Agenda Item No. 7  
**PLANNING AND DEVELOPMENT SERVICES  
DEPARTMENT**

**RE:** Consideration of a Design Review: Final Architecture and Site Review for a single family home on Lot SS811, 2 Mountain Village Blvd., pursuant to CDC Section 17.4.11

**RE:** Staff Memo – Initial Architecture and Site Review (IASR) for Lot AR25, 125 Lawson Point

## APPLICATION OVERVIEW: New Single-Family Home on Lot AR25

3 SITE PLAN- LOWER LEVEL EXT LIGHTING  
1/8" = 1'-0"

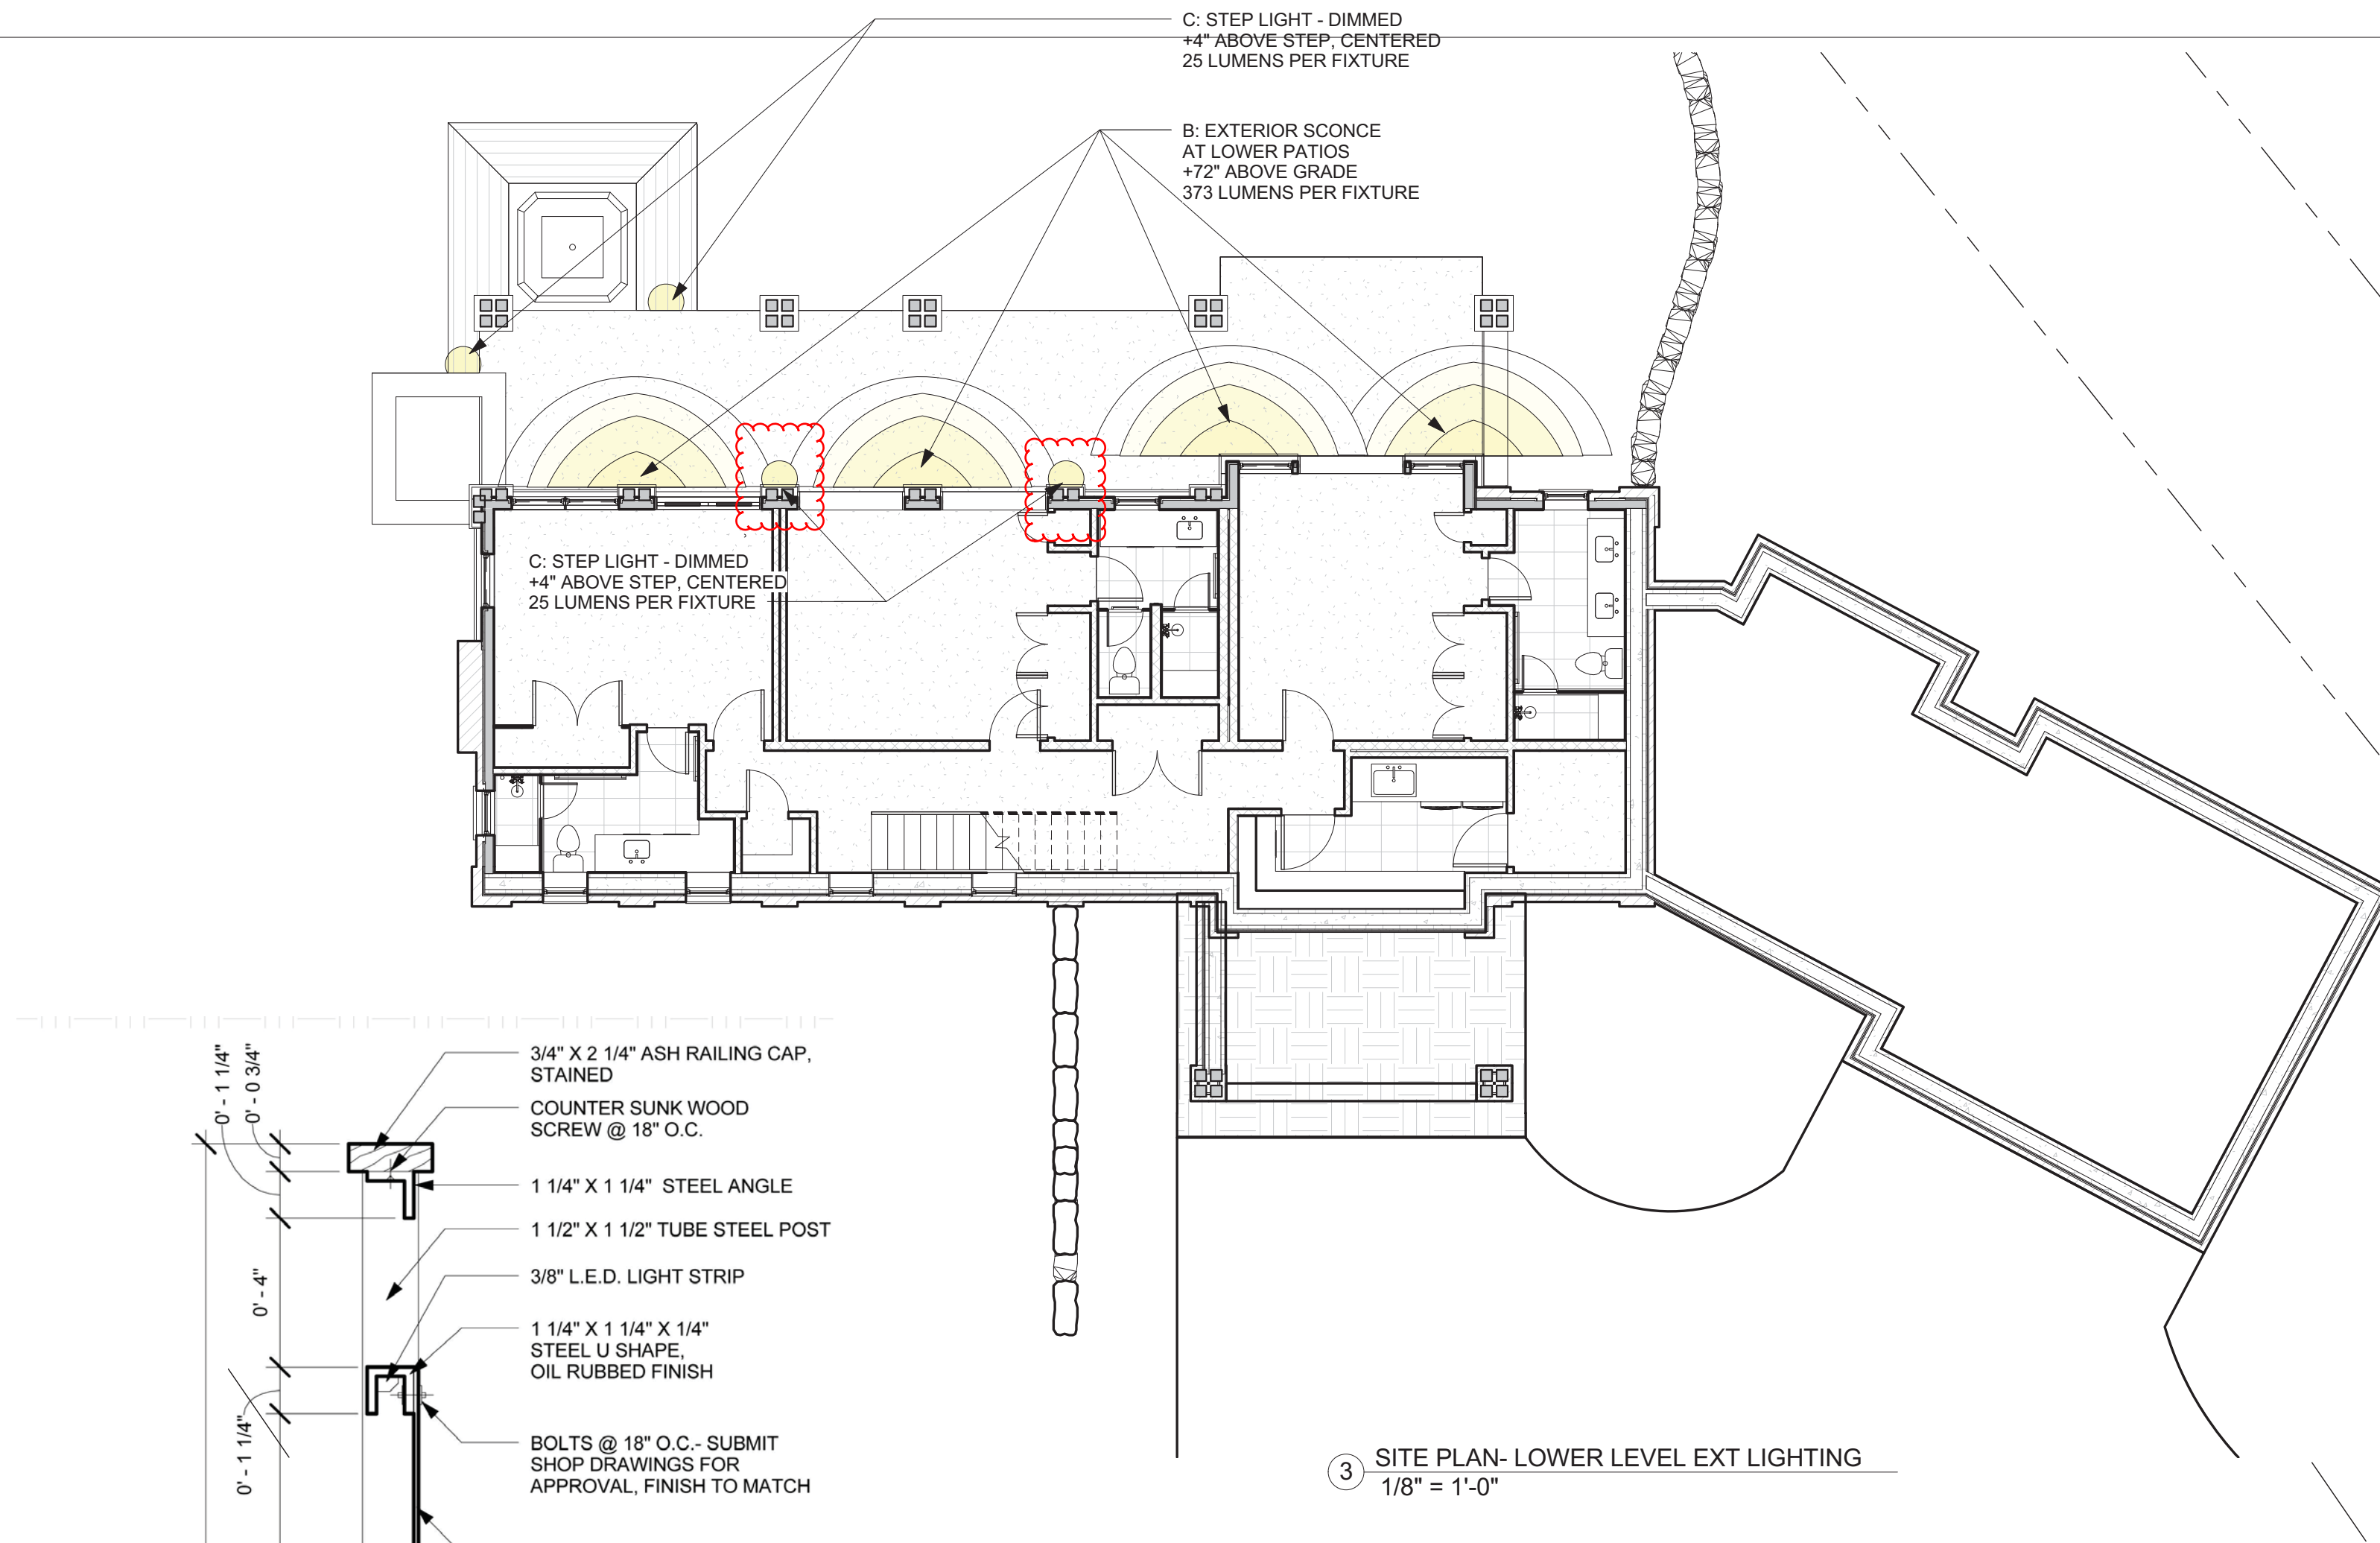
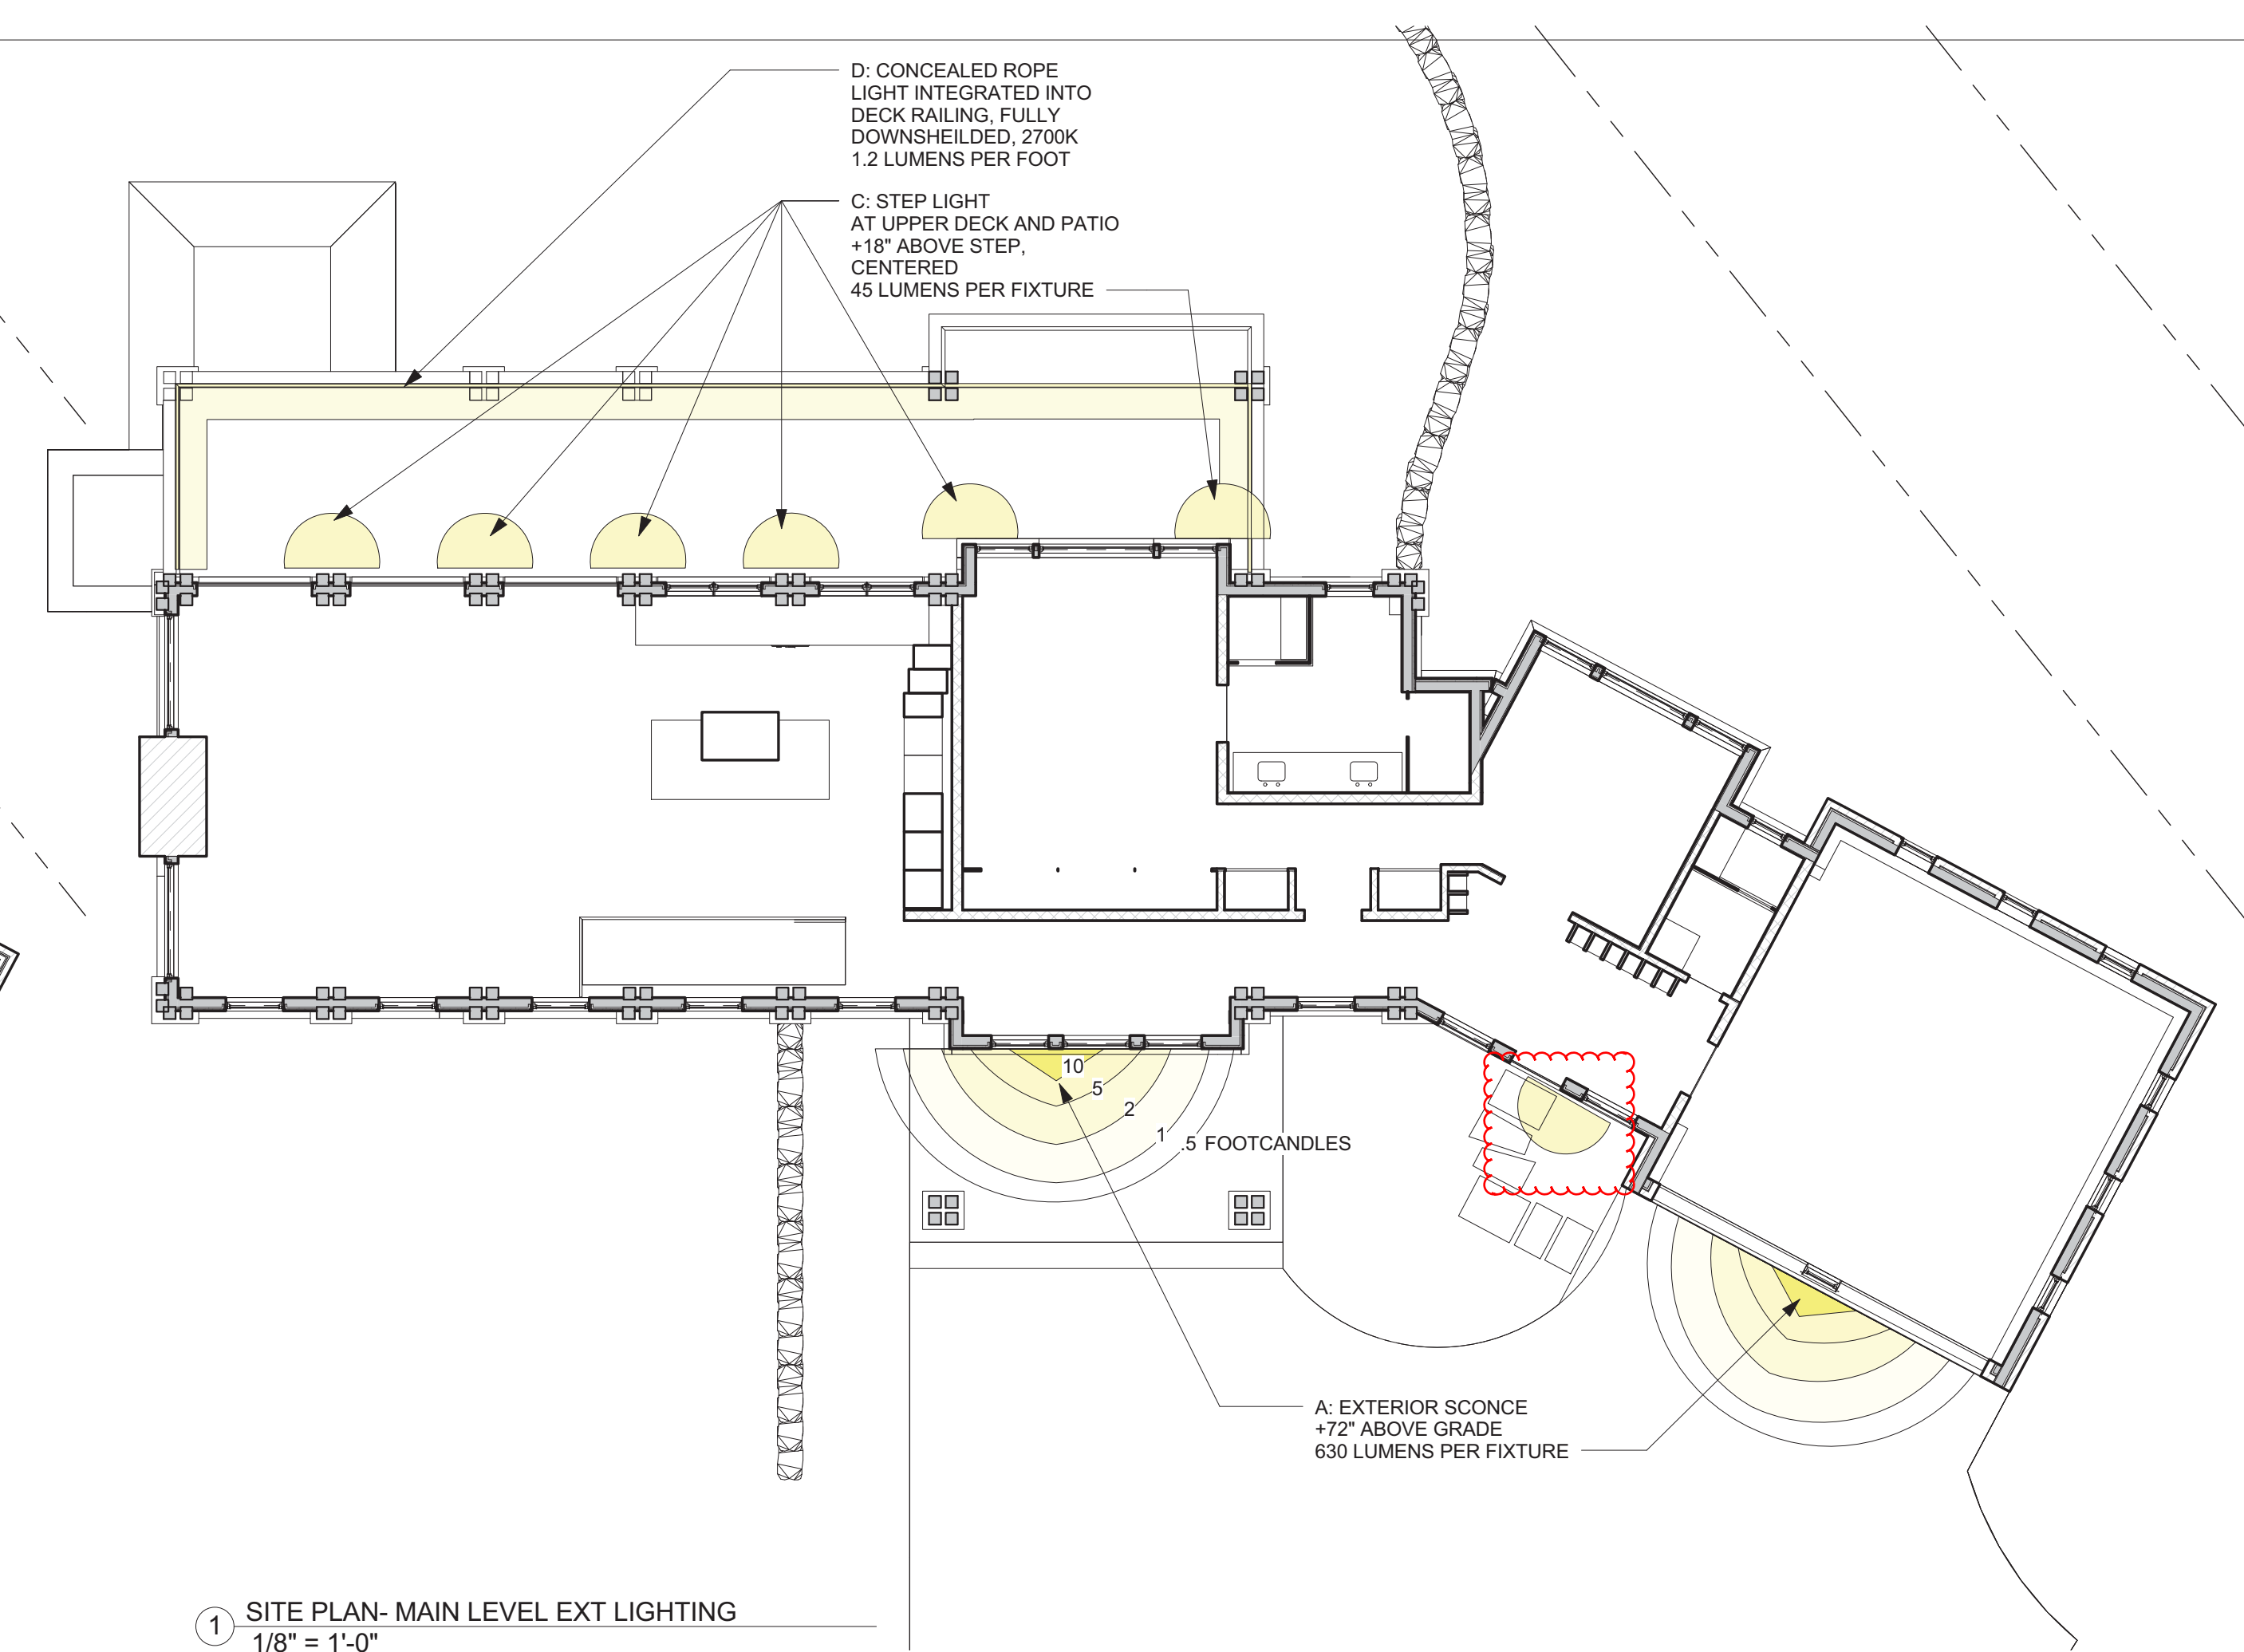
**Staff:** Lighting information was provided on sheet A1.2 of Exhibit A. This sheet indicates the use of two exterior light fixtures: a pathfinder LED outdoor wall sconce (labeled as Fixture A) and a LED 11251 up and downlight outdoor wall sconce (labeled as Fixture B). Fixture A is indicated in green below and is placed on the north facing façade in the backyard of the proposed structure. Fixture B is indicated to be placed along the garage and entrance of the structure facing Adams Way. An up and downlight does not meet the definition of a full cut-off. The lighting plan should be revised to show only a full cut off downlight.
